Author's response

Anonymous referee 1

Anonymous referee 2

Figure 1: a) Power Spectral Density (PSD) for each hydrophone drift of the study ($n=448$), the median PSD in black; b) Distribution of the frequency peak and central frequency of each PSD.

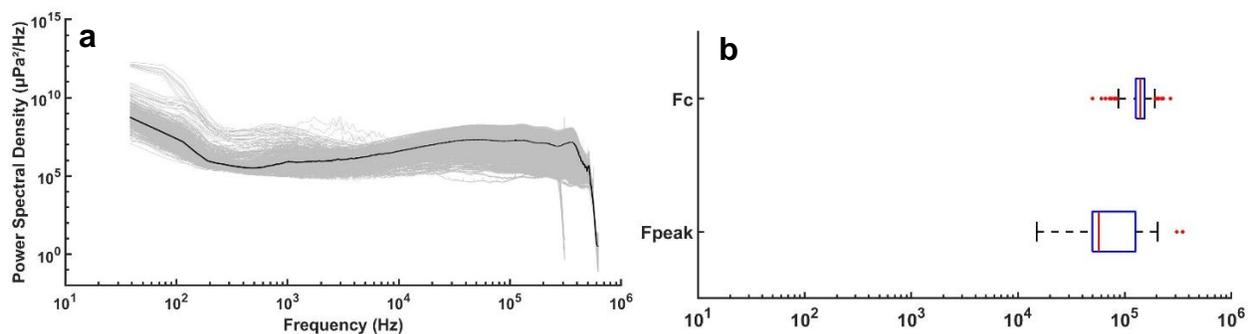
“Specifically, in relation to the hydrophone method, I would like to see a clearer explanation of the method and some data that demonstrate the variability of the power-spectral density between hydrophone recordings.”

We evaluated the variability of the PSD for all hydrophone records ($n=448$, Figure 1a). This variability is illustrated by computing the central frequency and the peak frequency in the frequency band of bedload (15-350 kHz) (Figure 1b). The central frequency is affected by the grain size and vary between 50 and 270 kHz with a median value of 140 kHz. The first quartile and the third quartile are 127 and 154 kHz respectively that reflect a small variability of the central frequency. This is in agreement with the median grain size of sediment (D_{50}) distribution that vary between 0.3 and 3 mm with a median value of 0.9 mm ($Q1=0.8$ mm and $Q3=1.1$ mm).

Figure 2: a) Comparison of PSD from 3 rivers with varying D_{50} ; b) Comparison between measured central frequency of PSD of the Loire River and related D_{50} with relation of Thorne (1986).

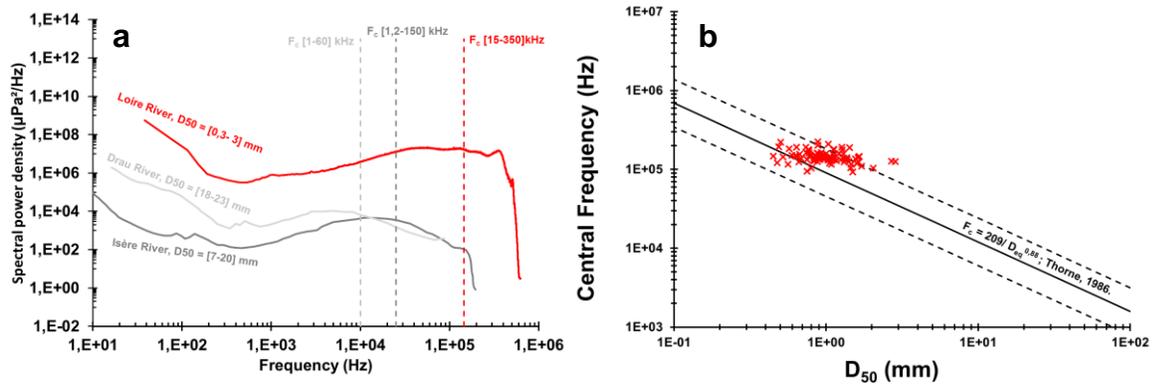
“I would like the paper to describe if there are significant differences observed between the frequency spectrum of the studied sandy gravel-bed river and the frequency spectra in the comprehensive literature on gravel-bed rivers. How does the different grain size distribution affect the observed frequency spectrum?”

Different frequency spectrum from three different rivers are plotted in the Figure 2a. As expected by Thorne (1986), the central frequency decreases with the D_{50} (Figure 2a). We acquired 98 concomitant hydrophone records and sediment samplings and we compared these measured values to the theoretical relation of Thorne (2014) (Figure 2b). For the investigated range of D_{50} , the central frequency measured are in line with the theory (82% of the dataset are in the factor 2). For this range of grain size, Geay et al. (2020) found that rivers investigated did not follow Thorne's law because of the attenuation of high frequency sound waves in these steep rivers. The shift of the bedload frequency band towards high frequencies (figure 2a) means more bedload signal in this area of the PSD. However, the slope of the study reach is mild and the turbulence is relatively

We propose to add the figure 2a to the section 4.1. in order to provide PSD information related to other rivers, and also a paragraph: “Moreover, the median PSD differ from the Isère River (Petrut et al., 2018) and from Drau River (Geay et al., 2017). These rivers are characterised by coarser sediments (see Fig. 5a) and the central frequency of the PSD are decreasing for an increasing D_{50} . These observations are in line with Thorne’s (1986) theory. The central frequency of the median spectrum of the Loire is about 140 kHz. The frequency band of the bedload is shifted towards high frequencies due to finer grain size.”

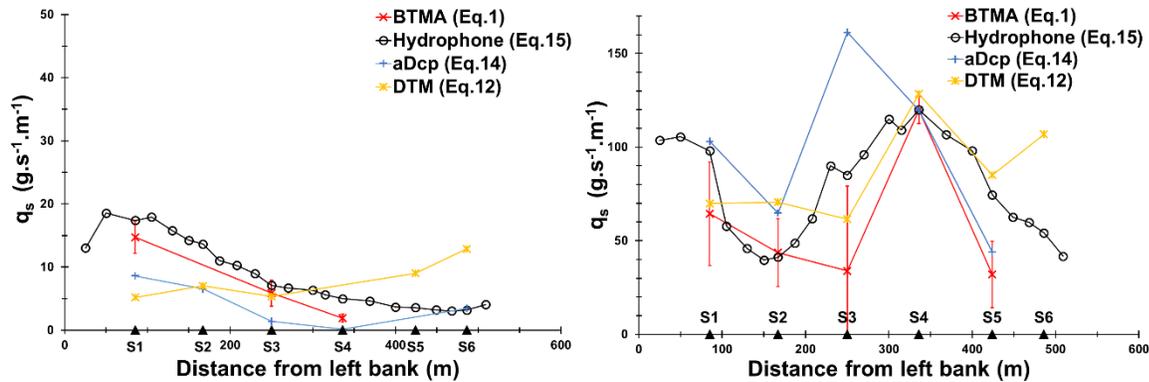
“Why not? Please explain. Can you please add labels, e.g. S1, to the BTMA data points in both panels of Fig. 8 to clearly identify the reference measurements? Why is there no S2 in Fig. 8a? Why are reference measurements missing from Fig. 8b?”

As mentioned in the material and method section, BTMA method is very time-consuming and it is not possible to measure all sampling points for each field survey. This is the case for S2, S5 and S6 on the figure 8a and also for S6 on the figure 8b. We added sampling points on figures 8a et 8b as requested:

Figure 3: a) Distribution of grain size statistical parameters for n=447 samples. b) Shields parameter as a function of particle Reynolds number (D_{50}) with Shields curve of critical parameter.

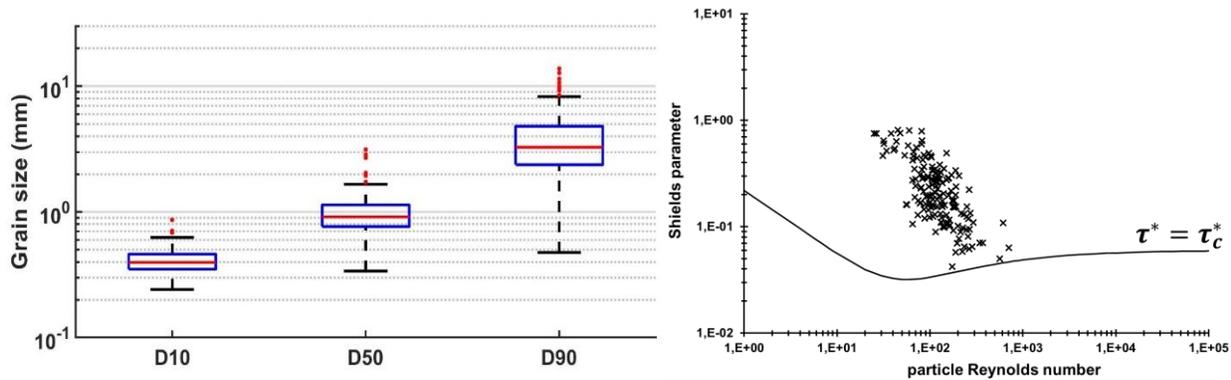
a) *“In the text, there is no info about the standard deviation of the particle's sizes of the bedload material. I would also like to see the range of the particle Reynolds number (Re_p), the shear velocity or stress and the critical shear velocity or stress. It could be also interesting if the authors give information about the reference shear stress at the study site (Parker et. al 1982). Note that this is similar to the critical shear stress but not the same.”*

As expected by the referee, we added some details about sediment characteristics in the text.

Hydraulic conditions and sediment characteristics allowed to compute the Shields stress (τ^*) and its critical value (τ_c^*) for 312 samples with the following equations (figure 1b):

Figure 4: Adaptation of figure 3a of the original paper with point color in function of aDcp device (Rio Grande/M9).

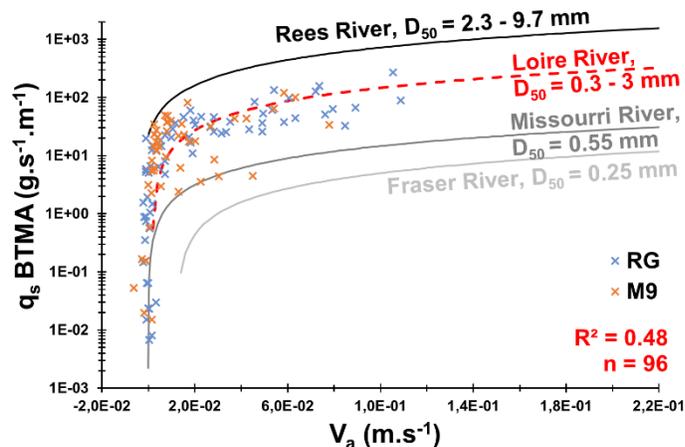
f) “In the results section, there is no distinction in the Figures between the data measured by the RDI 1200 kHz and the M9 (also which frequency). In Latosinski et al. (2017) and Conevski et al. (2020) it is clearly indicated that different ADCPs give different mean apparent bedload velocities, and it is not strictly dependent on frequency, but also to the acoustic sampling and resolution, pulse length, cell-profiling, signal processing etc. The laboratory tests are given in Conevski et al. (2019) and Conevski, et al. (2020) also confirm and elaborate on these issues.”

The scope of this paper is not to study the impact of frequency or pulse length on the apparent velocity. In that way, we did not mention these details in the figure 3a. But you can find details in the appendix B. About 55% of the dataset was measured with the RDI Rio Grande (1.2 kHz). You can find below the figure 3a adapted with the reference of the used device. It is clear that if we had been able to use the same device during all measurements it would be better.

Figure 5: View of a multibeam longitudinal track measured on the study site (scale=about 300 m long to 4 m width).

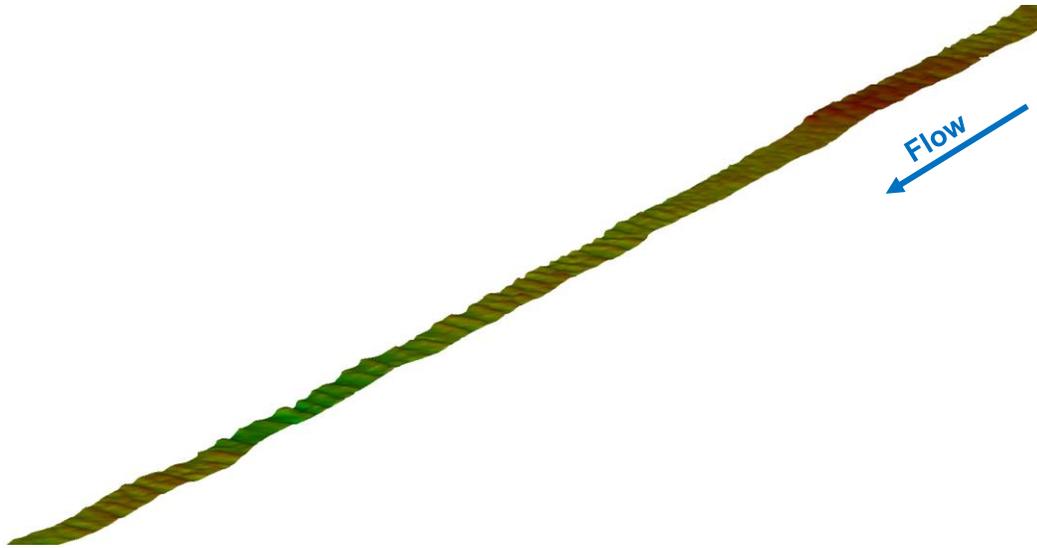
b) “On the other hand, the DTM method that you use is built based on well-developed 2D dunes. Could you please elaborate on this issue? I am afraid that maybe only the dune measurements in the thalweg zone would be most reasonable to use in the comparison with the other two techniques?”

We understand your comment. On the Loire River the DTM method was used on several sites because the 2D dunes were recognized on all these sites (multibeam echosoundings). Please see the following publications: Claude et al., 2012 & 2014; Rodrigues et al., 2012 & 2015; Wintenberger et al., 2015. If dunes are present in the thalweg for all discharge conditions, they develop rapidly on the back of bars since these latter are submerged (Le Guern et al., 2019). That means that most of the riverbed is covered by dunes when bars are submerged. Although the significant width of the channel makes difficult to perform multibeam echosoundings, we did a couple of them, in 2018, on some longitudinal tracks located on the back of bars present in the study site (please see figure below). As it can be seen on this figure, the dunes are clearly 2D dunes for the 3 longitudinal tracks presented.

Figure 8: Variable vertical position of hydrophone in the water column and associated acoustic power variation (red dots are the mean values of acoustic power).

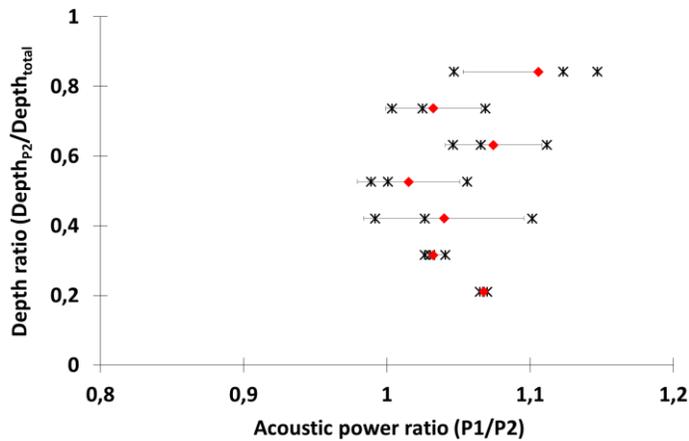
“L. 187-188: As this is a new method, this should be explained in more detail. Especially because acoustic power is affected by transmission losses that are a function of distance. It may be that the losses are negligible in the range considered here, but that should be demonstrated rather than just asserted.”

Several tests were carried out to ensure that these acoustic power variations are not due to the variation of the distance between the hydrophone and the riverbed. A total of 20 drifts were performed with two hydrophones on the same horizontal location. The vertical location was

constant for hydrophone P1 (0.4 m depth) and variable for hydrophone P2 (from 0.4 m to 1.6 m depth). 3 drifts were done for each P1 and P2 configurations (except for P1 and P2 at the same depth, 2 drifts). When P1 and P2 are at the same depth, the acoustic power ratio is about 1.06, so the two hydrophones measured approximately the same acoustic power. This ratio doesn't evolve linearly with the proximity of river bed (depth ratio increasing). Even if the largest acoustic power ratio is observed for the largest depth ratio, it varies between 0.98 and 1.15 with a mean standard deviation of each configuration of 0.03 (see figure 1). This means that acoustic power can be considered as independent of the listening depth until 85% of the water depth.
